Technical Service Bulletin

Transaction No.: **2078803/1**

96 Driver assist systems: side assist issues warnings for no reason - A5

Figure 1. Left side of vehicle with towing bracket, bumper carrier opening sealed off with aluminum adhesive tape.

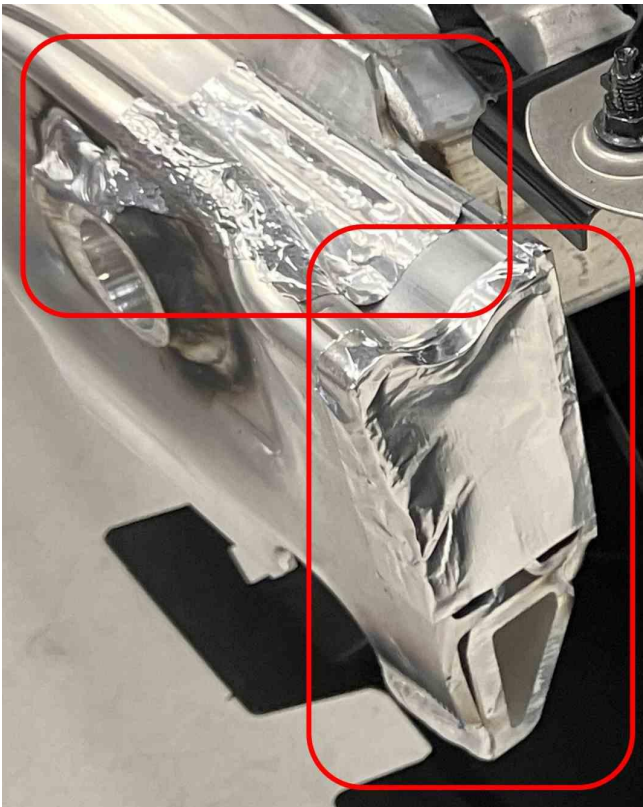
Close off the openings on both sides of the bumper carrier. Please use aluminum adhesive tape to do this.

When attaching the aluminum adhesive tape, please ensure that there is a small drainage opening at the bottom so that water can drain.
